Document last modified: 9/16/14

**CORRECTIONS FOR EROSION AND SEDIMENT POLLUTION CONTROL PROGRAM MANUAL**

**TGN 363-2134-008 March 2012**

**STANDARD CONSTRUCTION DETAIL # 7-12  
Sediment Basin Emergency Spillway with Riprap Lining**

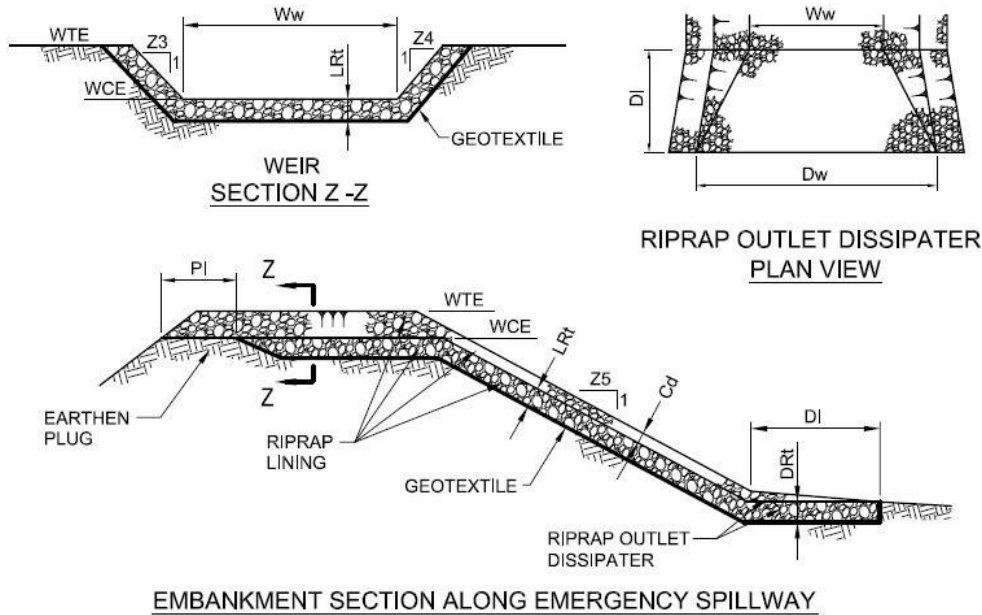
193
